ADDENDUM NUMBER 1

DATE: 12/20/2024

PROJECT: SEMCO Emergency Operations Center

ARCHITECT/ENGINEER: Anderson, Eckstein & Westrick, Inc.

10 FATIGUE ROOM DETAIL
A511 1" = 1'-0"

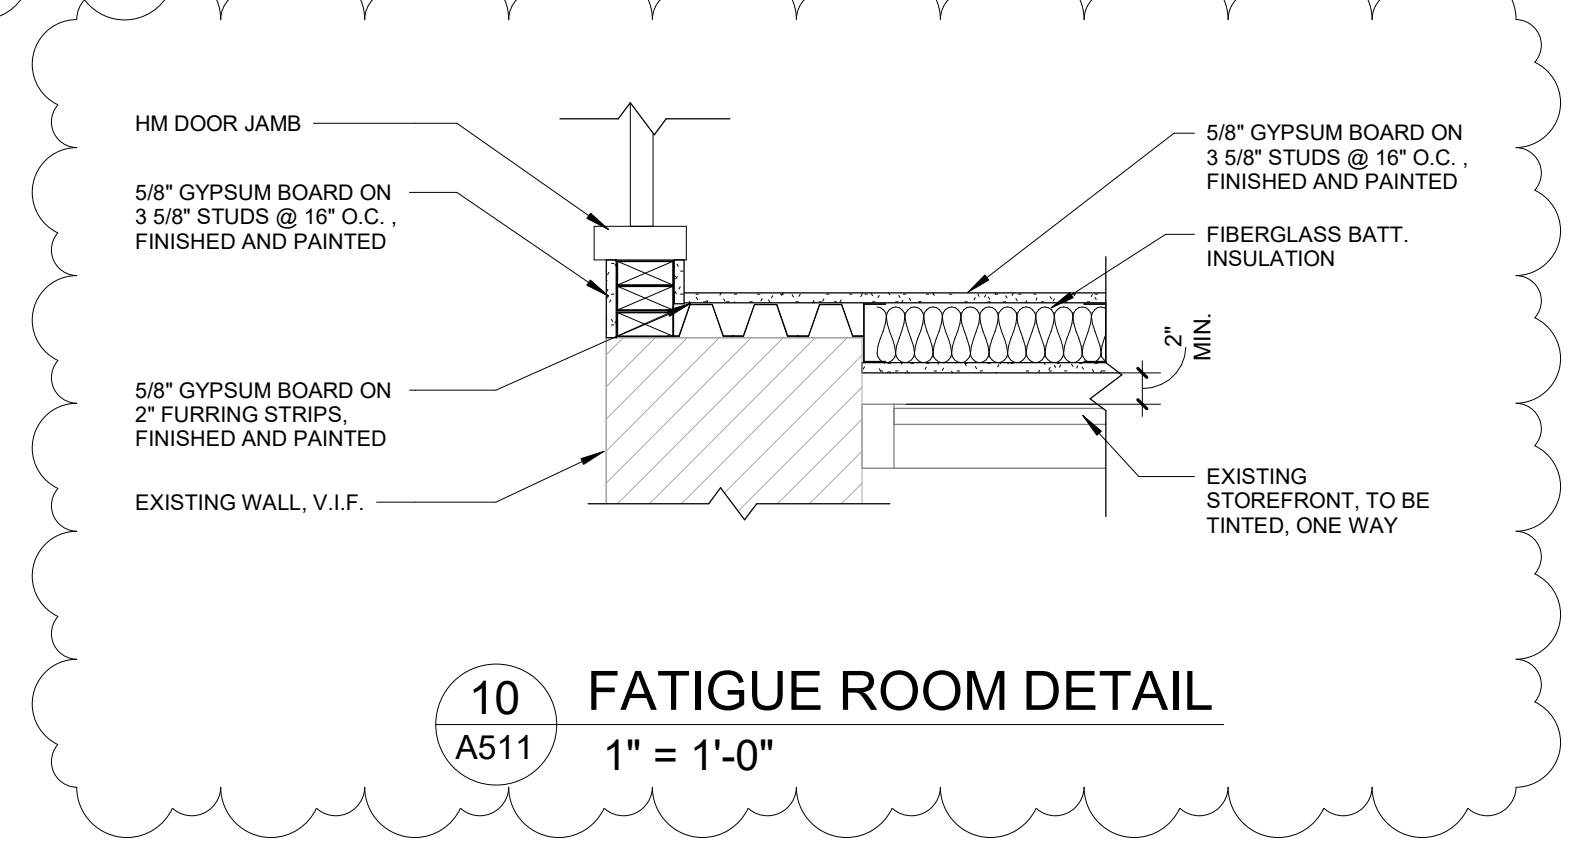
1. SHEET A101: reissued
 - a. Partition moved 2" off existing curtain wall
 - b. Added UL Listing U301 for partition type A1
 - c. Added Gas Supervisor Office Callout 11/A511
 - d. Added Fatigue Room Call out 10/A511
2. SHEET A301: reissued
 - a. Partition moved 2" off existing curtain wall
 - b. Detail 2 added dimensions for window tint
3. SHEET A412: reissued
 - a. Toilet 109 revised to Toilet 107
 - b. Toilet 117 revised to Toilet 114
4. SHEET A511: reissued
 - a. Detail 3 partition moved 2" off existing curtain wall
 - b. Detail 4 partition moved 2" off existing curtain wall
 - c. Detail 10 added
 - d. Detail 11 added
5. SHEET A611: reissued
 - a. Revised Toilet room wall finishes

A611

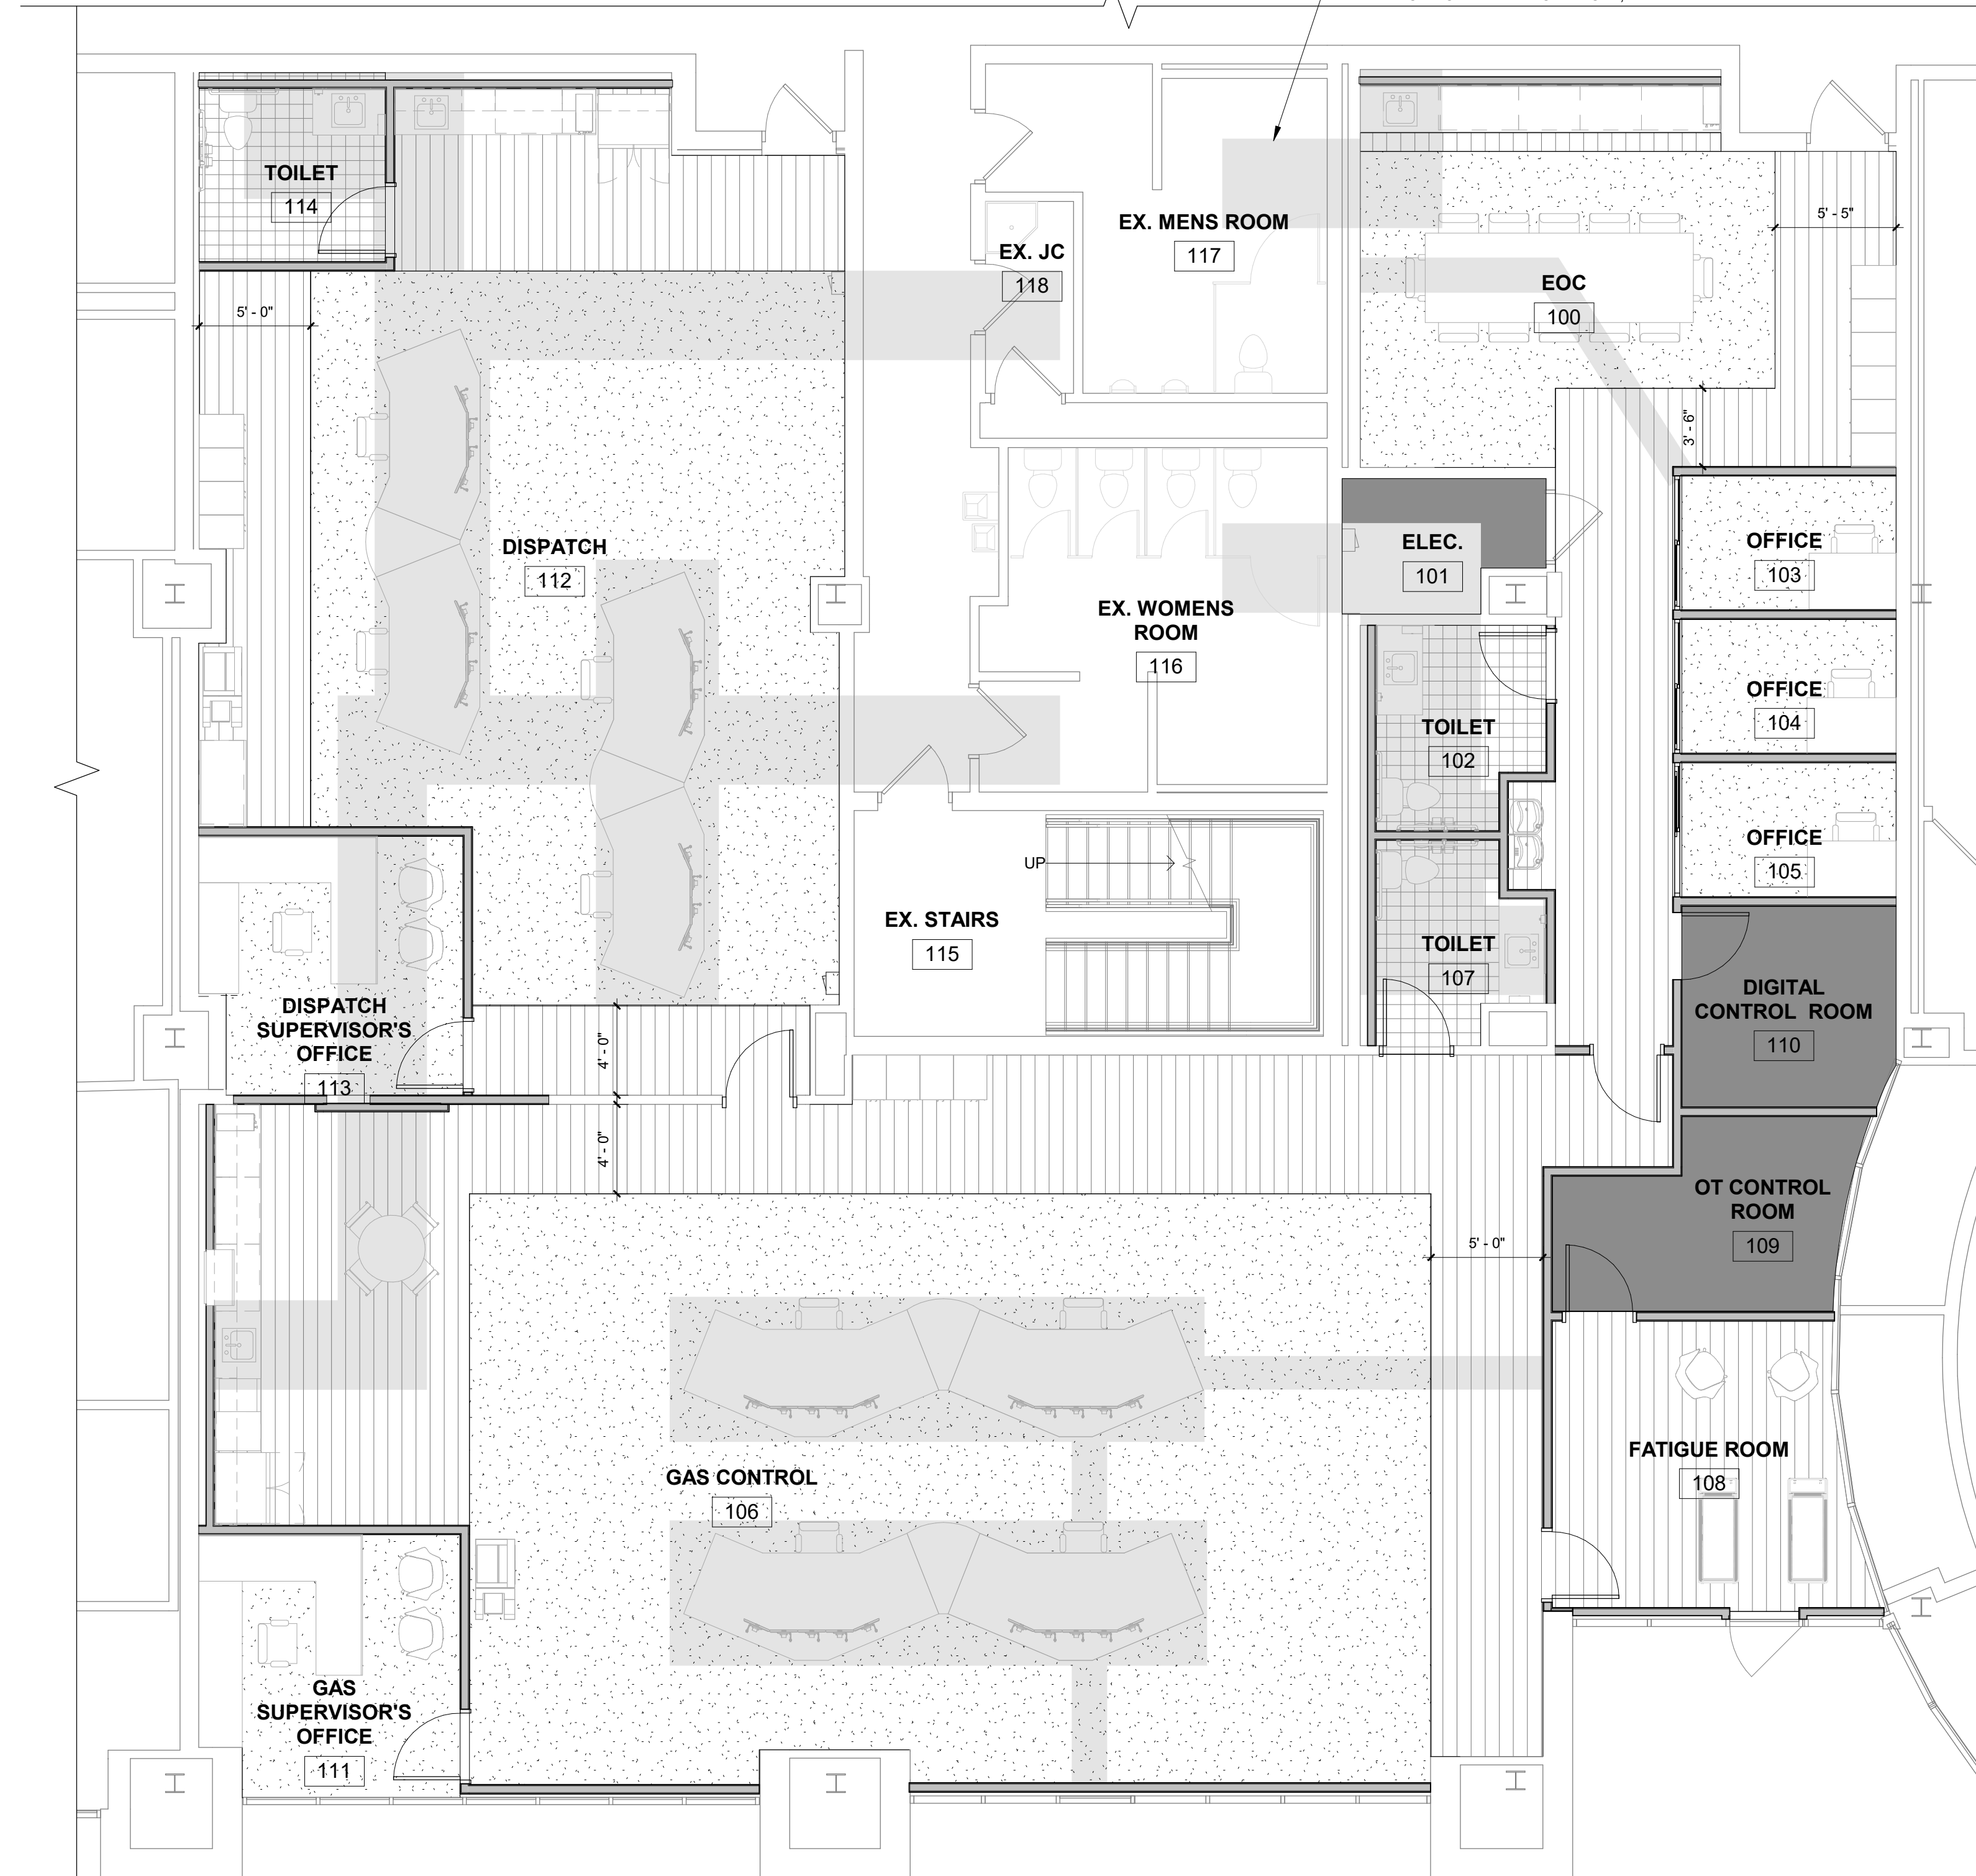
3. **Q:** Room finish schedule shows 3 Toilet rooms, 102, 107 & 114, all to have tile on all 4 walls, but elevations show only 2 wet walls to be tiled. Please clarify. Also, what about existing toilet rooms 116 & 117? They are not listed on room finish schedule, but there is an elevation showing 2 walls for room 117. Please clarify.
A: Refer to revised room finish schedule for selected walls to have tile up to 4'-0" in Toilet rooms. Interior Elevations 1 and 2 on A412 are referring to Toilet room 114, names have been revised. Toilet rooms 116 and 117 are not included in the scope of the project. The only work in Toilet Rooms 116 & 117 is replacing the floor as required for new sanitary lines, include allowance to match existing flooring.

P102

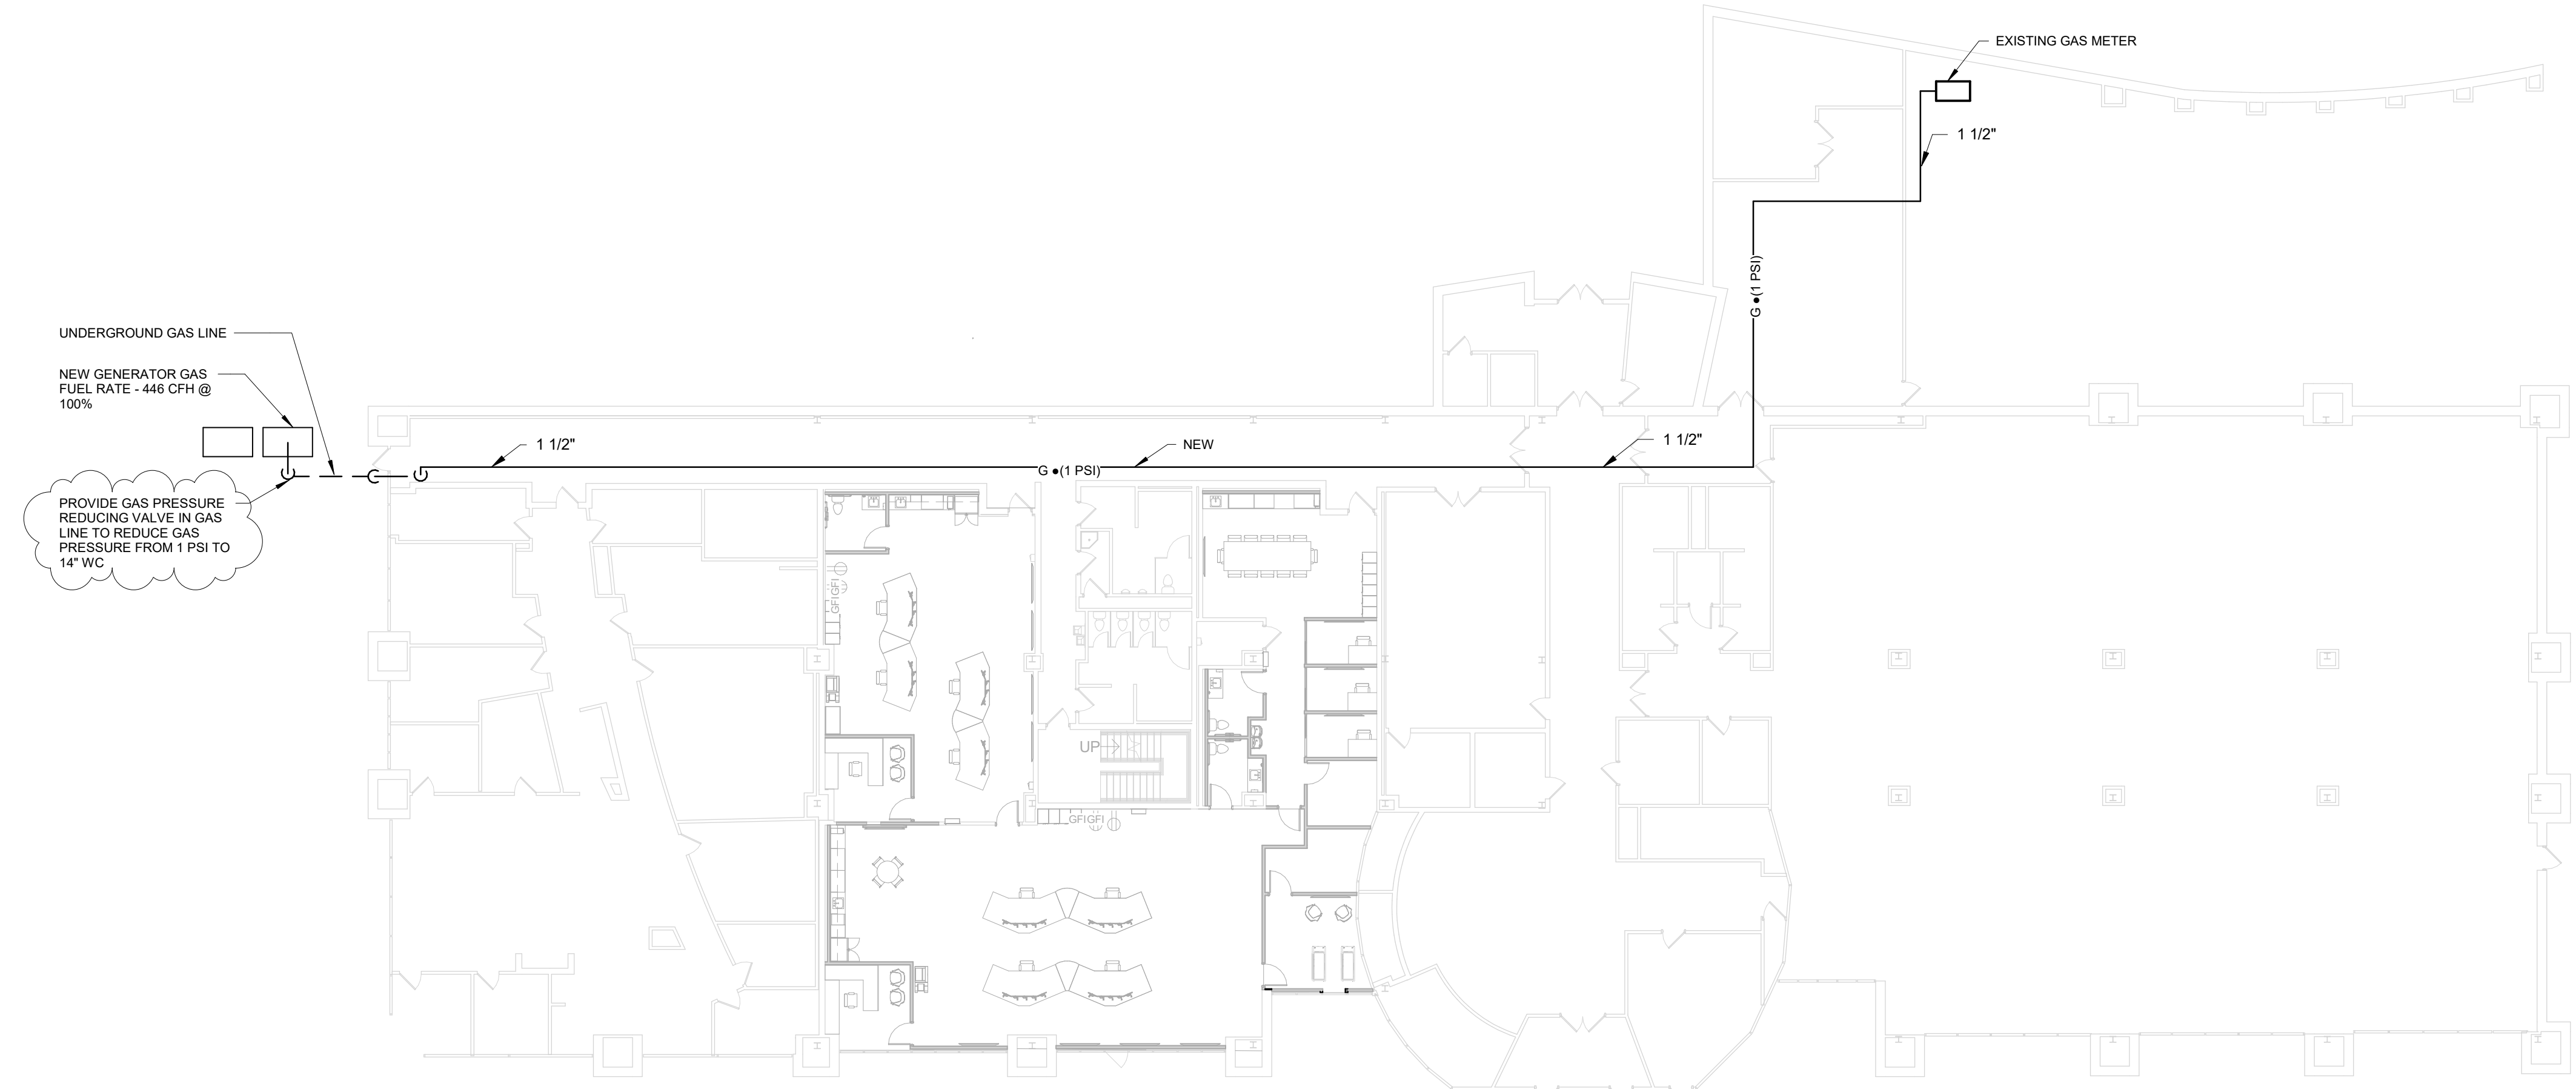
1. SHEET P102: reissued
 - a. North arrow revised
 - b. Reducing valve spelling error
